AK Wildlife Conservation Center (Milepost 79 Seward Highway)

- Placement of planned new access driveway (ATC #23516)

12/31/2013 MSC

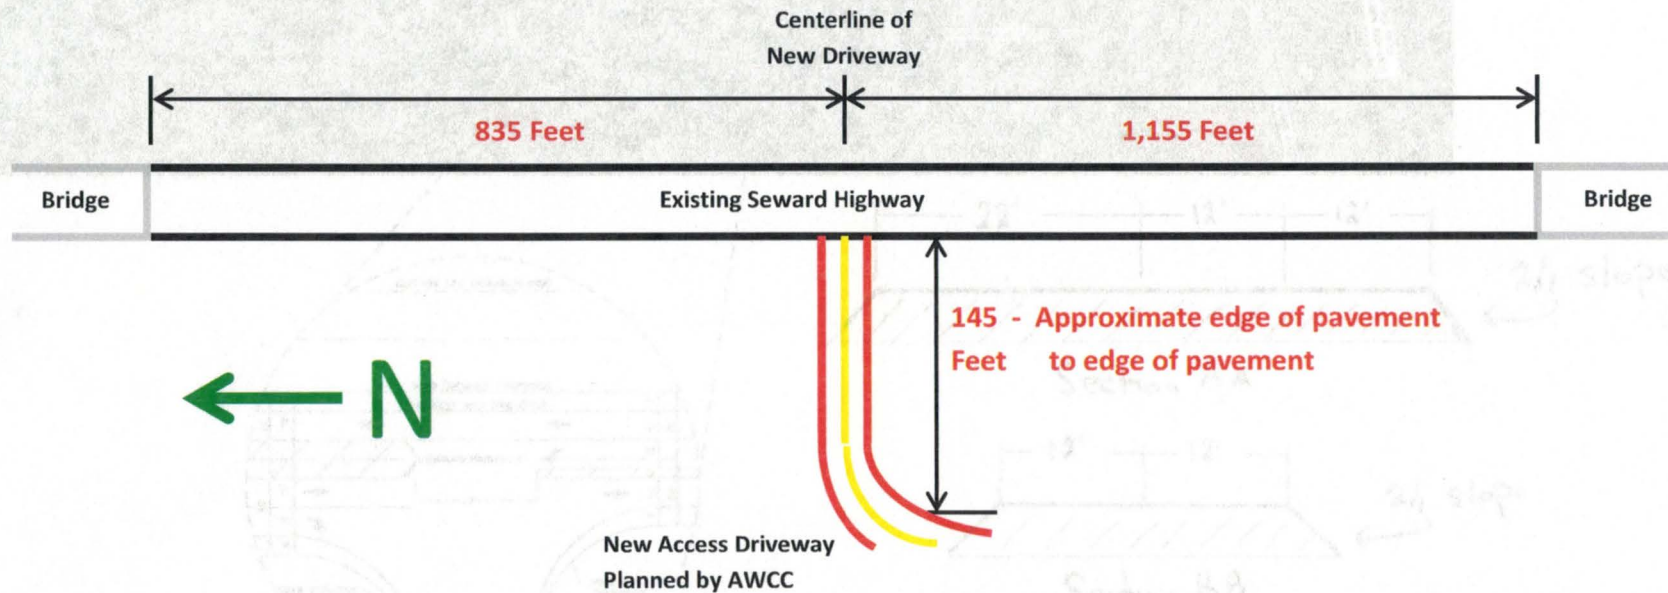
Because of a planned future re-alignment of the Seward Highway (including left and right turn lanes into the new driveway), the new driveway should be placed according to the dimensions below :

This placement will better allow for the necessary lengths to fit in the turn lanes. The planned realignment will move the entire highway to the west. The set back of the curved portion of the driveway from the edge of the existing road will leave enough room for busses at the stop sign once the highway has been moved. See attached overlay of current permit drawing for clarification of the discrepancy. Note that the permit should stipulate that all access construction work, including side slopes, must be outside of the Right-of-Way. The "145 Feet" figure is an approximate, easy to check value.
